**City Planning Commission Meeting**  
**Tuesday, April 14, 2015**

### PRELIMINARY STAFF REPORT

**To:** City Planning Commission  
**Design Review:** 119/14

DR 119/14 - 4430 Bundy Road

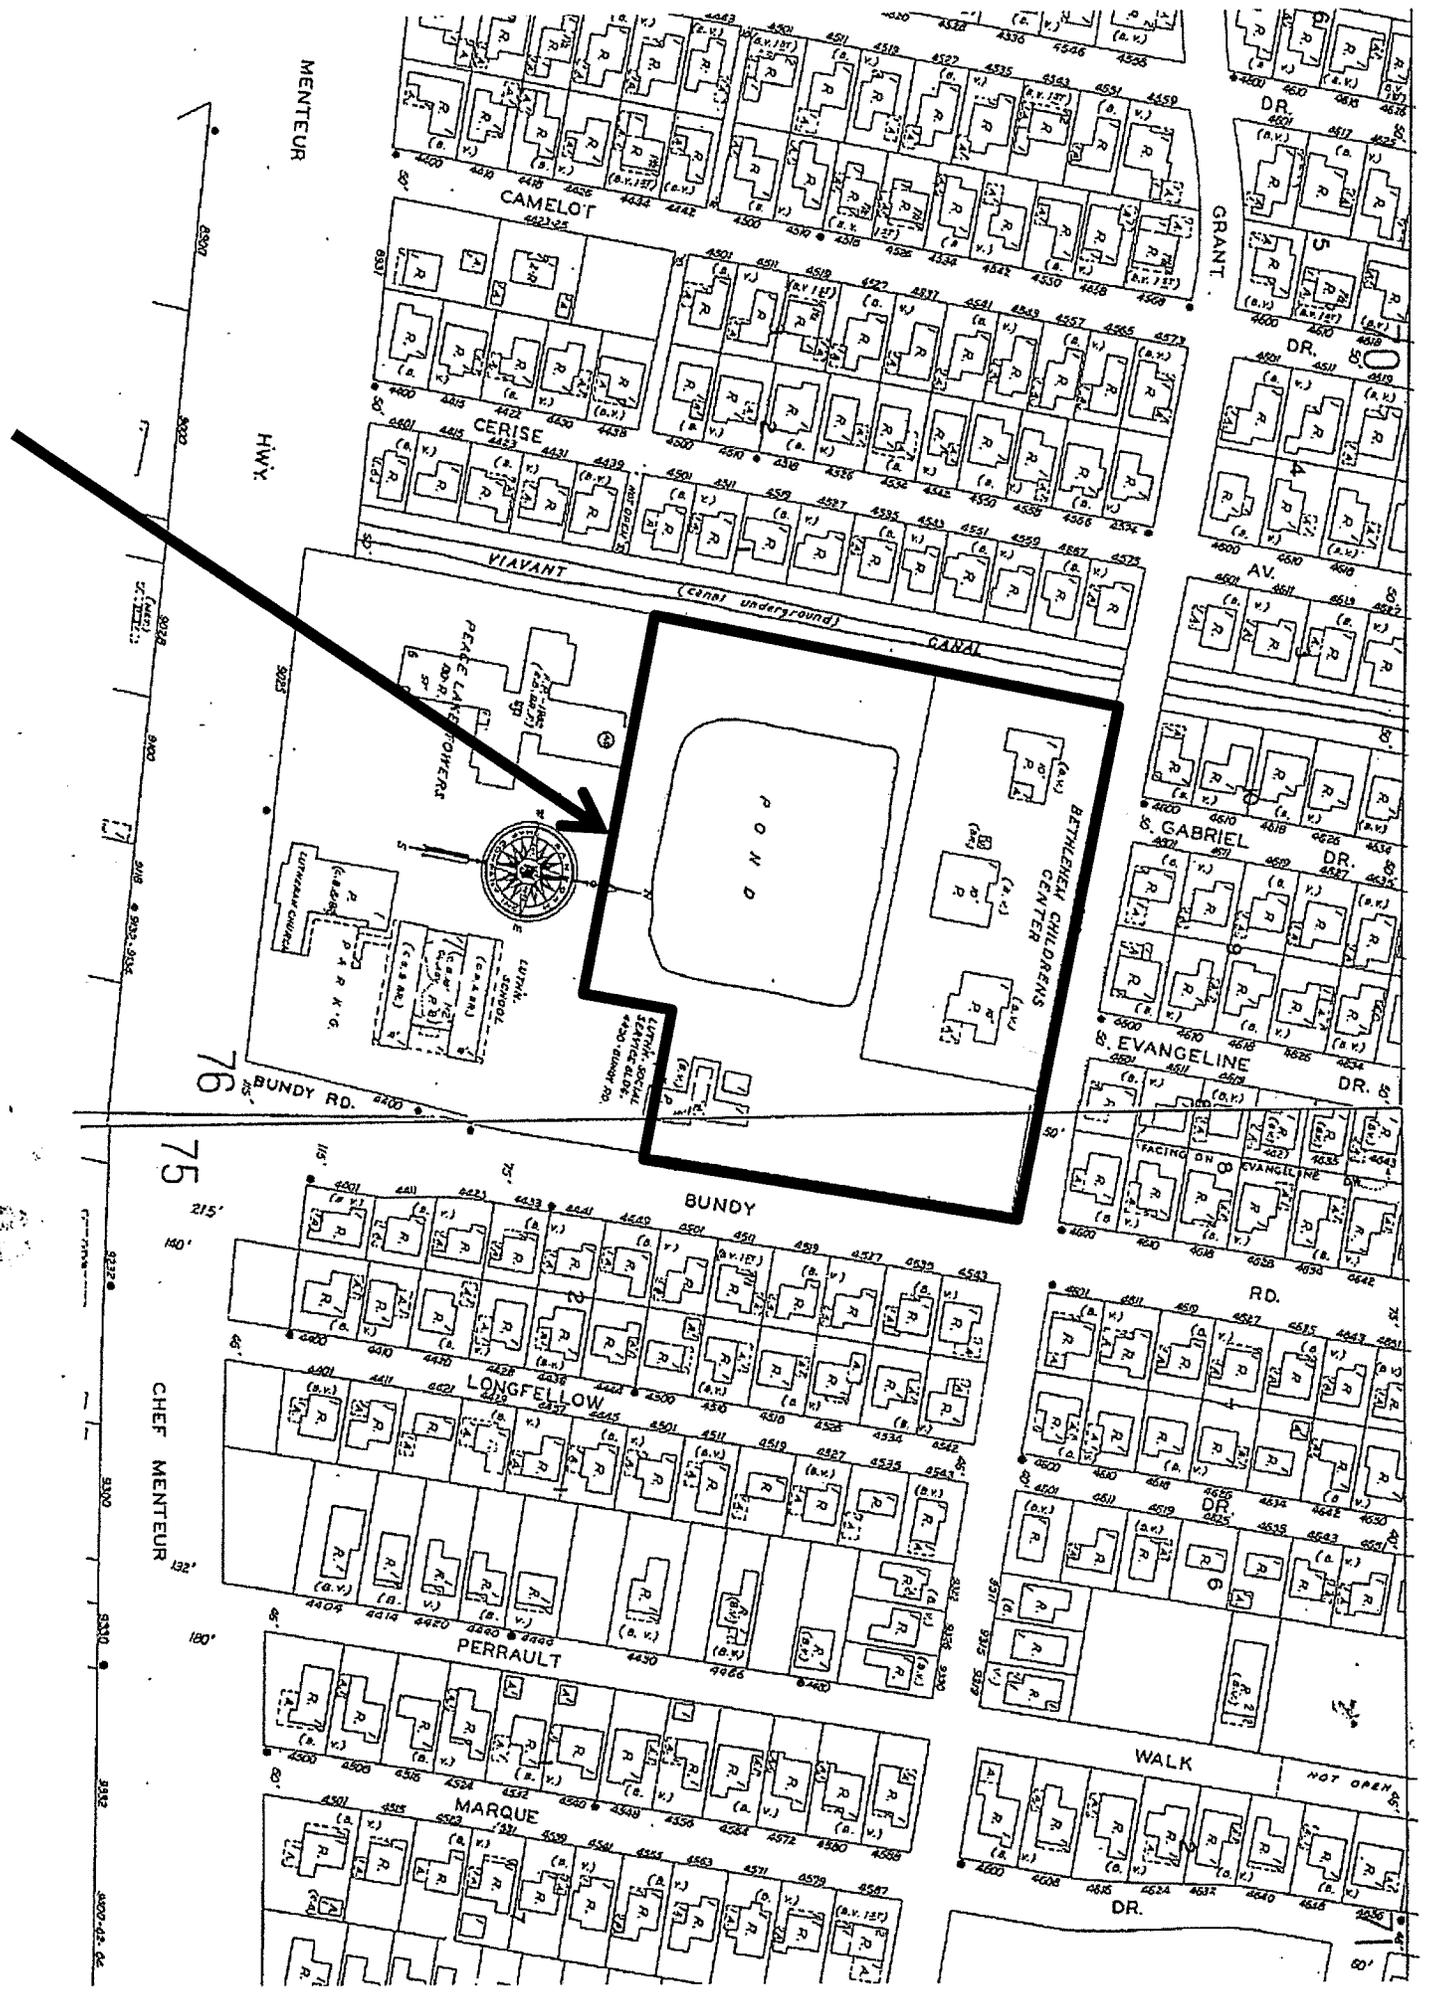
Need to know scale 0' 1' 2' etc

OPA - New Orleans Baptist Monument - 4430 Bundy Road New Orleans LA

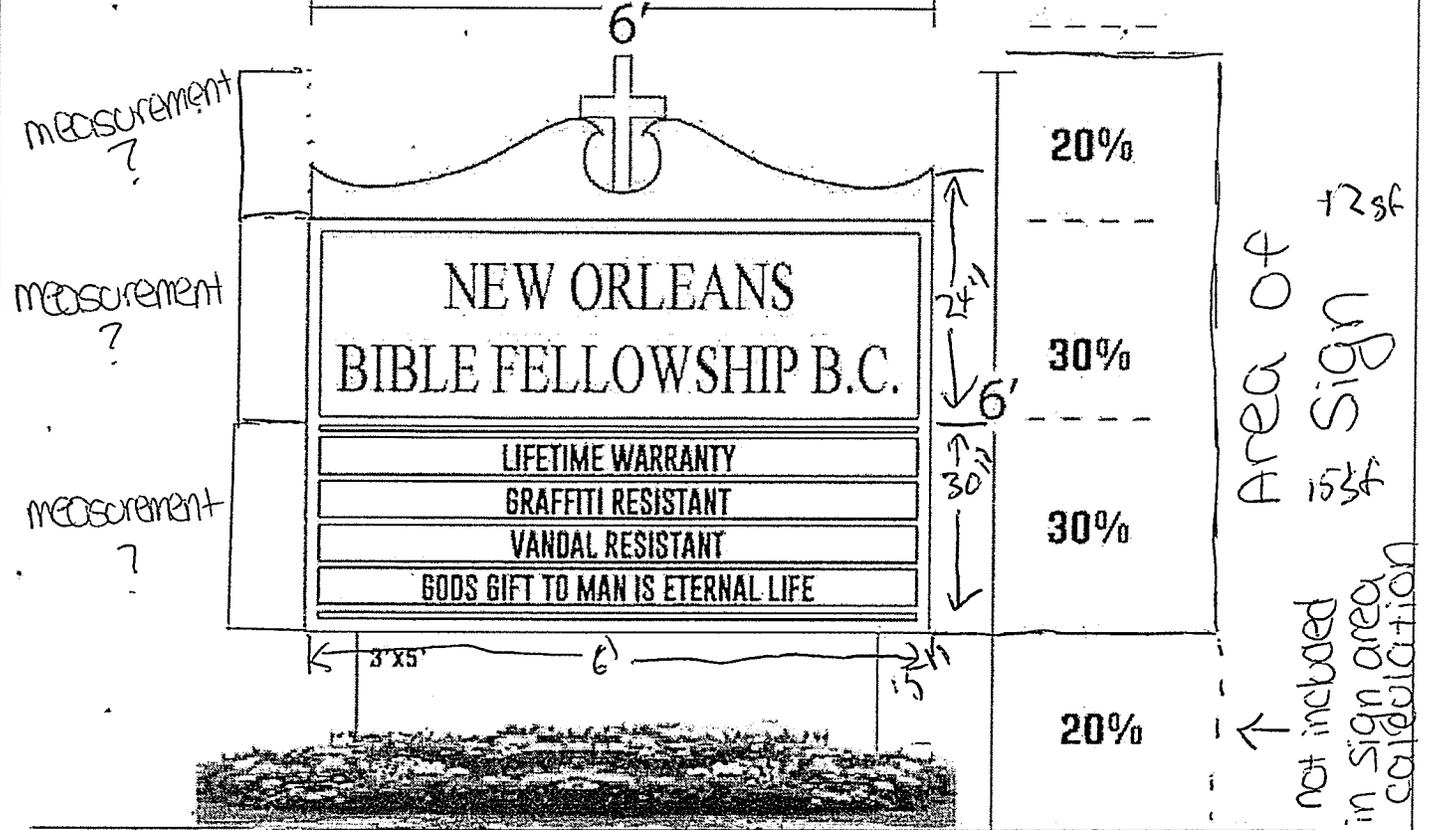
indicate plant materials and quantity

27sf

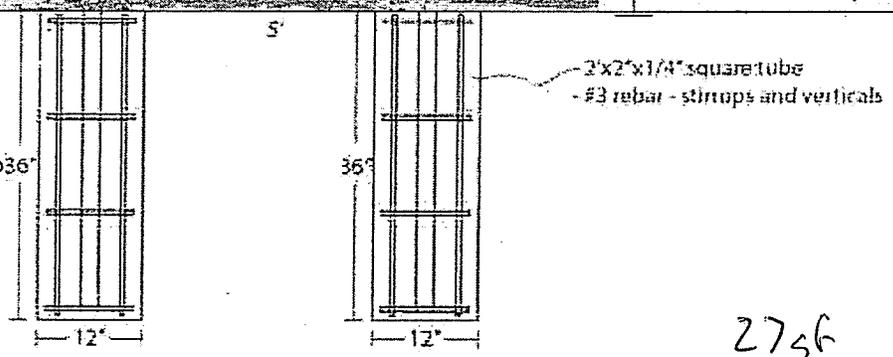
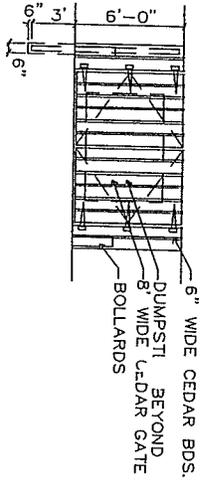
part of the sign face will contain approximately 15 square feet or 56% of the total sign area. Therefore, the applicant needs a variance of 6.9 square feet or 26% in addition changeable message area.

Based on the size of the site, a maximum permitted sign area for a detached sign for this property is 70 square feet,<sup>8</sup> and the respective message area could contain up to 21 square feet. As proposed, the total sign area is 27 square feet and the changeable message area is 15 square feet. To comply with this requirement, the applicant could propose to increase the total sign area to at least 50 square feet so that the changeable message area is only 30% of the total sign area. This would be inconsistent with the goal of the Eastern New Orleans Urban Corridor (UC) District which seeks to improve urban design by limiting the size of signage.

In addition, with a literal reading of these regulations, one could argue that the applicant “shall be limited to thirty (30) percent of *the total permitted sign face area*” of 70 square feet, allowing for 21 square feet of changeable message area. Finally, the applicant received a permit to build a sign, and had detrimental reliance on the determination that the Department of Safety and Permits made by issuing the permit. Therefore, the staff would prefer to keep the total sign area as proposed and built and to allow for a greater proportion of changeable message area. Therefore, the staff recommends:

- The applicant shall be granted a waiver of **Article 10, Section 10.1B.9.1 (c) – Permitted Changeable Message Area** which limits the size of the Changeable Message Area to 30% of the total permitted sign face area to permit a Changeable Message Area of up to 15 square feet, or 56% of the total sign face area.

1. The applicant shall be granted a waiver of **Article 10, Section 10.1B.9.1 (c) – Permitted Changeable Message Area** which limits the size of the Changeable Message Area to 30% of the total permitted sign face area to permit a Changeable Message Area of up to 15 square feet, or 56% of the total sign face area.
